**CULTURAL RESOURCES OFFICE
PRESERVATION BOARD
REGULAR MEETING
MONDAY - DECEMBER 1, 2014 — 4:00 P.M.
1520 MARKET ST. #2000
ST. LOUIS, MO. 63103
www.stlouis-mo.gov/cultural-resources**

DATE: November 24, 2014
ADDRESSES: 1901-03 Dodier/3015 N. 19th
ITEM: Preliminary Review of Demolition: a two-story alley house
JURISDICTION: Murphy-Blair National Register Historic District — Ward 3
STAFF: Betsy Bradley, Cultural Resources Office

DATE: November 24, 2014
ADDRESS: 2413 South 10th Street
ITEM: Preliminary Review to construct a single family house with detached garage
JURISDICTION: Soulard Certified Local Historic District — Ward 7
STAFF: Bob Bettis, Cultural Resources Office

DATE: November 24, 2014
Address: 1720 Carroll Street
ITEM: Preliminary Review Application to revised details of a one-story side porch previously granted Preliminary Approval by the Preservation Board
JURISDICTION: Lafayette Square Local Historic District — Ward 7
STAFF: Jan Cameron, Cultural Resources Office

REAR BUILDING AT 1901-03 DODIER

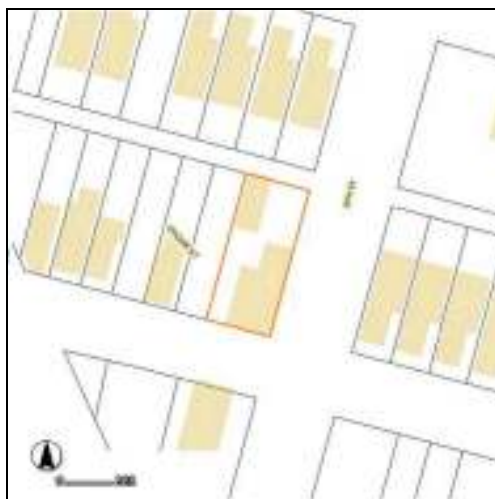
This two-story brick flounder appears to have been built in three sections. Inspections of the building in 2009 and in November 2014 by the Cultural Resources Office staff both note that the south end of the building appears to be an addition to the northern two-thirds of the building. The damage is confined to this south portion and the larger block of the building is sound. This situation raises the question of partial demolition as a solution to retaining the northern two-thirds of the flounder.

- The condition of the flounder includes a limited collapse at the south end, a condition that has existed since 2009, verifying that a majority of the building is sound.

The Cultural Resources Office recommends that the Preservation Board withhold approval of demolition, as the main portion of the building remains sound, and request that the owner explore the possibility of partial demolition.

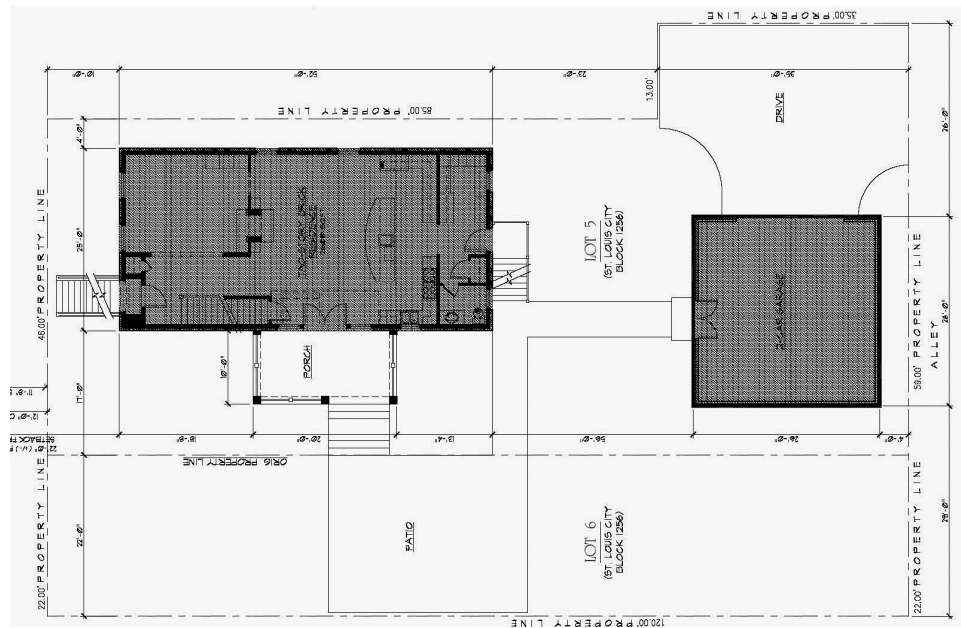
The owner, concerned with maintenance issues, now wishes to fabricate the handrail (in approximately the same design) in metal. The Cultural Resources Office has not received details of the proposed rail, but presumably it would appear less substantial and have a flatter, less three-dimensional quality than the wood railing of the HME.

The owner also is asking to delete the spindled frieze from the plans and install only simple brackets at each post. The frieze is a character-defining feature of the HME porch and will be prominently visible from Carroll Street above the privacy fence proposed to be constructed.

With no frieze, the scale of the porch and roof visually expand and their uncharacteristic depth is more apparent.

Based on the Preliminary findings, the Cultural Resources Office recommends that based upon its previous determination, the Preservation Board, should withhold preliminary approval of the project as it does not comply with the Lafayette Square Historic District Standards nor with the Preliminary Approval previously granted by the Board.

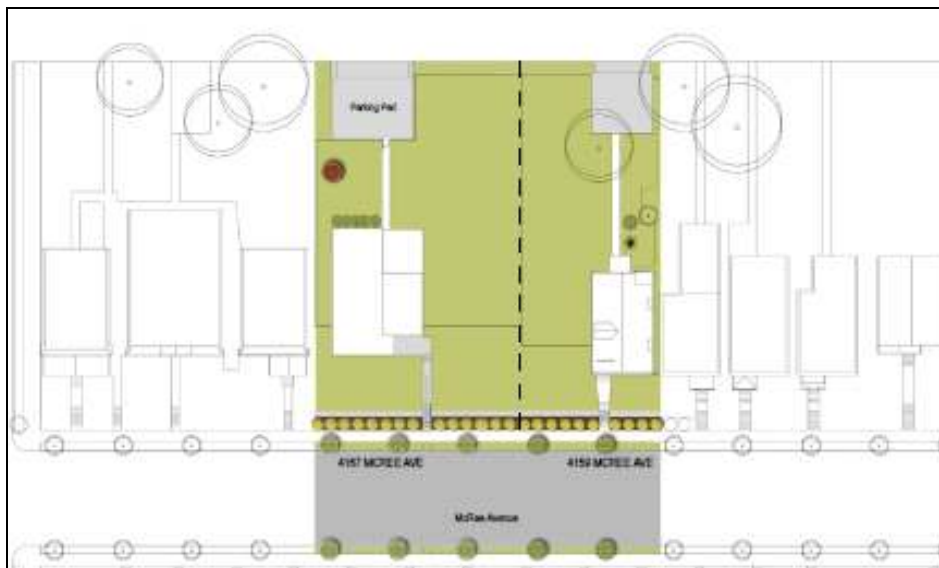
Cementboard siding does not comply. The material has been accepted as a substitute for wood siding, although it appears in a much larger extent than suggested by the standards. Lapped cementboard with a four-inch reveal will clad approximately one-half of the front façade and the street-facing portion of the side wing. The material is proposed in two colors, a very dark gray, comparable in saturation of color to the red brick, for the walls on all facades that are not brick. A light color, “Rainwashed” in the green palette of Sherwin Williams, will be the color the lapped siding that sheathes the top portion of the façade. These colors do not “unify the area” as the standards require.

Spacing does not comply. The extensive side yard adjacent to the side yard of the house to the east reduces the relationship of the set-back position with that property, with which it is aligned. The spacing of the houses with wide side yards disrupts the pattern of closely-spaced residences.

Does not comply. The single-pitch roof of the main portion of the façade is not a roof form or pitch found on the block. Flat roofs predominate on the block; the adjacent building has a more steeply-pitched gable roof. The roof material will be architectural shingles in a dark grey color.

Based on the preliminary findings, the Cultural Resources Office recommends that the Preservation Board withhold preliminary approval and direct the applicant to propose compliant materials and colors, and address the shape of the roof, as requested by the Preservation Board at its October 2014 meeting.

4055 FLORA PL.

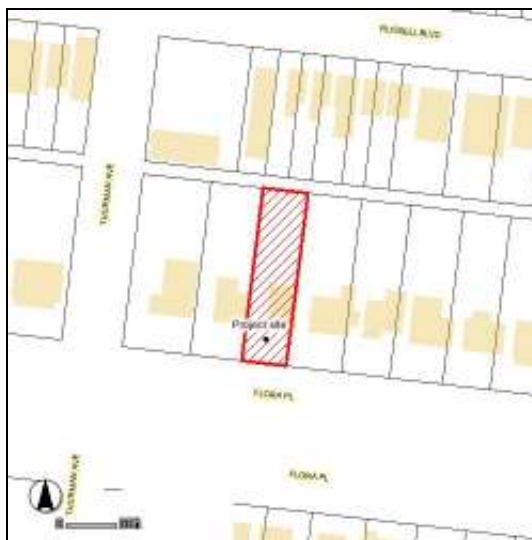
The applicant has a building permit application to retain concrete block retaining walls in front of the building at 4055 Flora Place. The applicant started the lower retaining wall without a permit and when a Stop Work Order was placed, applied for a permit. The application was denied as the retaining walls did not meet the Shaw historic district standards. The owner appealed the denial. Representatives of the Shaw Neighborhood Improvement Association had indicated to the staff that they had contacted the owner, who had agreed to remove the walls or lower them to a curbing height. However, it appears the owner was not in fact willing to change her plans, and completed most of the walls. As the time for appeal has expired, the application is being brought before the Board as a new application.

That the Preservation Board uphold the Director's denial, as the retaining walls do not comply with the Shaw Historic District Standards.

1021 S GRAND

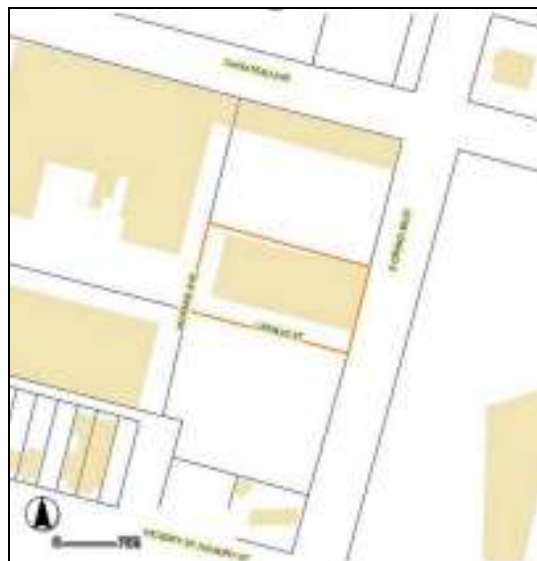
The corner Pevely Dairy building and the Missouri Belting Company building provide context for each other and suggest the extent of the historic industrial development that was evident on this block. The loss of the Missouri Belting on a block face that has diminished continuity and rhythm can be considered to be either not important due the changes that have already occurred, or as a remnant to be retained.
